## 12.0 PARTIES CONSULTED DURING THE PREPARATION OF THE FINAL ENVIRONMENTAL IMPACT STATEMENT

The Hawaiian Memorial Park Cemetery Expansion FEIS was prepared for the Petitioner, Hawaiian Memorial Life Plan Ltd. by Helber Hastert & Fee, Planners. The following list identifies individuals and organizations involved in the preparation of this report and their respective contributions.

FIGURE 1: Proposed Stream Monitoring Location

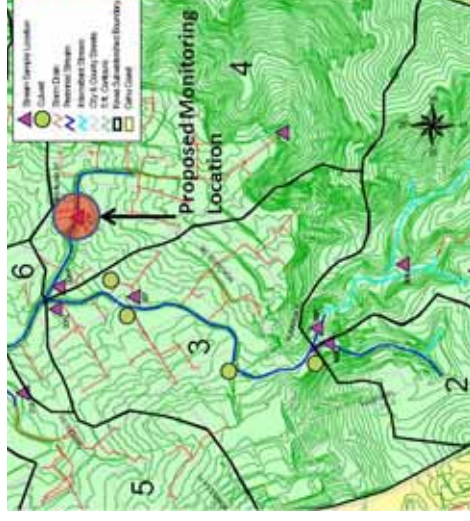
In order to evaluate potential changes to dry and wet season baseflow water quality resulting from the proposed development, baseline monitoring will be initiated at Station 16 (DOH's Monitoring Station 6). This proposed monitoring station is located in the upper portion of the Kawa watershed that receives baseflow from sub-basin 4 of the TMDL analysis (the area directly impacted by the proposed expansion) (Figure 1).
